## Jane Farwell - CCRB Comments on 2nd RDEIR for the Cachuma Project

Re: Comments on April 2011 2nd Revised Draft Environmental Impact Report for Consideration of Modifications to the United States Bureau of Reclamation's Water Right Permits 11308 and 11310 (Applications 11331 and 11332), State Clearinghouse No. 1999051051)

**APPENDIX A**

## TECHNICAL MEMORANDUM

Figure 1. Combined frequency of scores 4 and 5 from RDEIR Tables 4-43-4-45.

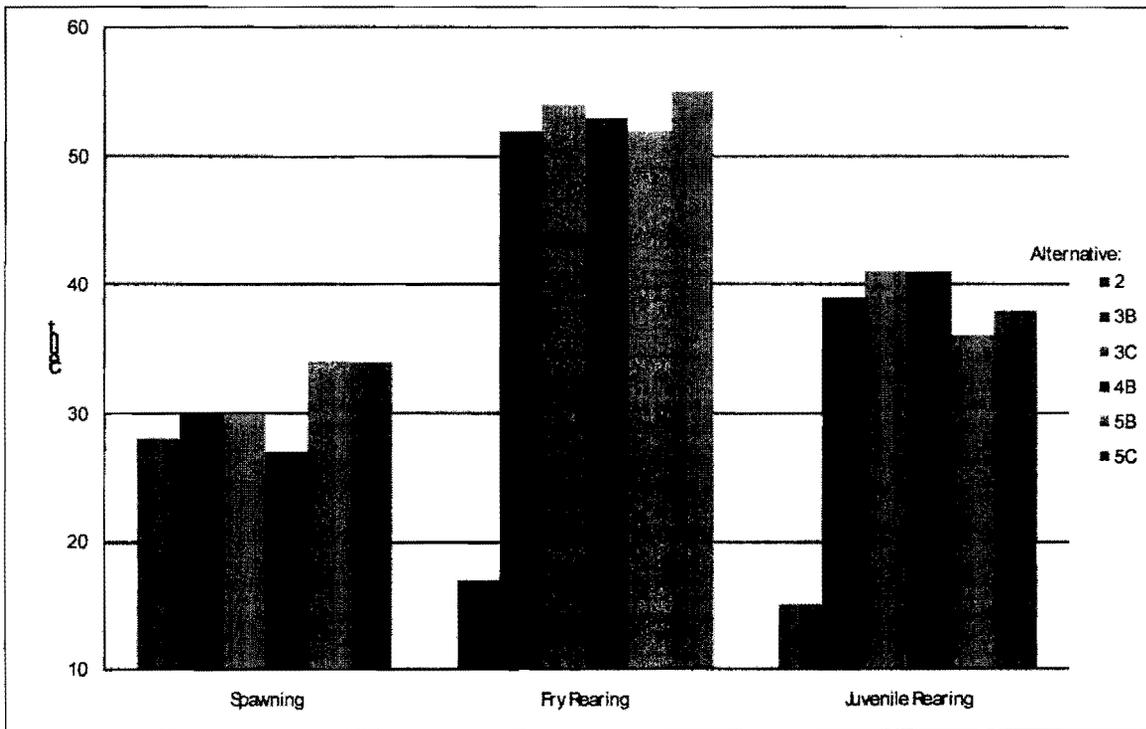
The analysis of the alternatives on steelhead spawning and rearing in the Lower Santa Ynez River is divided into three separate analyses summarized in Tables 4-43 – 4-45 (RDEIR pages 4.7-46 – 4.49; see also Figure 1 below). The separate analyses conclude that all four alternatives result in a beneficial effect on steelhead spawning and rearing compared to baseline operations with “Alternatives 5B and 5C showing the most benefits to rearing” (page 4.7-49, paragraph 4). We disagree with this statement in that in our estimation this analysis should integrate all life stages and habitat relationships of steelhead/rainbow trout in the Lower Santa Ynez River and account for habitat bottlenecks when evaluating the alternatives.

CCRB agrees with the analysis that all alternatives result in a beneficial effect on steelhead/rainbow trout spawning over baseline conditions. We note that the differences in habitat improvement for spawning between Alternatives 5B and 5C and Alternatives 3B and 3C are insignificant. Examination of Table 4-43 reveals that Alternatives 5B and 5C are superior to Alternatives 3B and 3C (based on the scoring criteria) in only 6 percent of the years. This improvement, however, is offset by an increased frequency of years receiving a score of 1 (2.6 percent of years as compared with Alternatives 3B/3C). Increasing the frequency of years with poor habitat is likely to have a greater impact to steelhead/rainbow trout spawning and survival than increasing the number of years with scores of 4 to 5. The analysis does not consider the greater impact to the population at the lower end of the scale in evaluating the scores.

In examining the impacts to rearing habitat, the analysis should account for habitat bottlenecks which, in the Santa Ynez River, occur during the juvenile lifestage. While Alternative 5C shows

a slight advantage over Alternatives 3B, 3C, 4B and 5B for fry rearing (RDEIR Table 4-44; Figure 1 below), Alternatives 3B, 3C and 4B have an advantage over Alternatives 5B and 5C for juvenile rearing (RDEIR Table 4-45; Figure 1 below). Habitat bottlenecks during the juvenile life stage affect later life stages, i.e., the adult steelhead population size. This would eliminate any minor advantage that could accrue for steelhead during the spawning or fry stage. Steelhead fry produced during the spring grow into juvenile fish and continue to reside in the River through the fall and into the winter when habitat is limited. Thus, any additional fry produced under Alternatives 5B or 5C must pass through a habitat bottleneck occurring during the juvenile rearing stage. Alternatives 3B and 3C and Alternatives 5B and 5C provide similar flows in fall and winter. Therefore, in view of the potential limitations to juvenile rearing in the lower Santa Ynez River, Alternative 5B or 5C would not be expected to increase production relative to Alternative 3B or 3C, since the same habitat limitation would apply at the juvenile rearing stage. These considerations indicate that it is unlikely that Alternatives 5B and 5C will provide any additional benefit to steelhead/rainbow trout over Alternatives 3B and 3C.
